VORGESCHRIEBENE TECHNISCHE MITTEILUNG**MANDATORY SERVICE BULLETIN****NR. MSB-20-050/1****NR. MSB-22-005/1****SUPERSEDES / ERSETZT MSB-20-050 & MSB-22-005****I TECHNISCHE ANGABEN****I.1 Kategorie**

I.2 Betroffene FlugzeugeMuster/Variante:
DV 20, DV 22
Werknummern: alle**I.3 Dringlichkeit**Einbau des Distanzrings:
Beim nächsten Wartungsereignis,
jedoch nicht später als 30-Jun-2007.Die Demontage des Distanzringes
und der Einbau der Elemente (Art.Nr.:
DV2-9032-23-01) hat in jedem Fall
bis spätestens 31-Dez-2007 zu
erfolgen.**I.4 Gegenstand**Inspektion des Bugraddämpfers und
Einbau eines Distanzringes zum
Ausgleichen eines erhöhten
Setzverhaltens der Gummielemente
oder Tausch der Elemente auf Art.Nr.
DV2-9032-23-01**I TECHNICAL DETAILS****I.1 Category**

I.2 Airplanes affectedType:
DV 20, DV 22
Serial Numbers: all**I.3 Time of Compliance**Installation of the polyamide spacer:
At next scheduled inspection, but not
later than 30-Jun-2007.The demounting of the polyamide
spacer and installation of the
elements PNo.: DV2-9032-23-01
must be carried out not later than
31-Dec-2007.**I.4 Subject**Inspection of the Nose Landing Gear
Damper and installation of a spacer to
compensate the increased

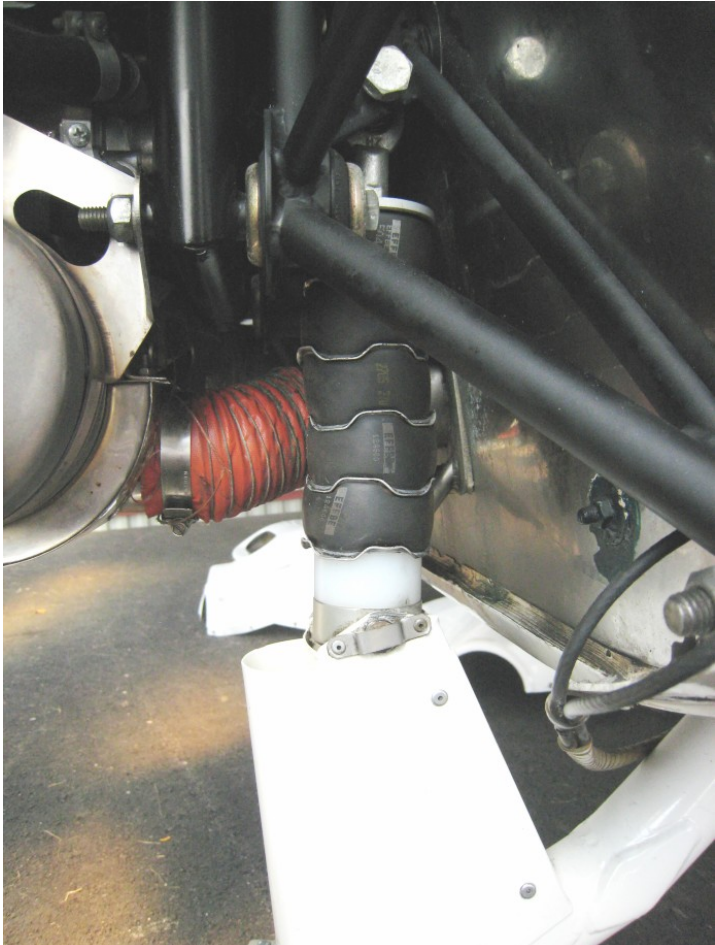
1	Remove engine cowlings acc. to AMM.
2	Remove nose landing gear cover.
3	Remove bottom screw from damper.
4	Install Polyamide Spacer acc. to picture.

5	Install bottom screw of damper and adjust damper acc. to values given in the AMM.
6	Install nose landing gear cover.
7	Clean working area and check for foreign objects.
8	Install engine cowlings acc. to AMM.
9	Check all systems in working area for proper function.
10	Make appropriate entries into aircraft log.
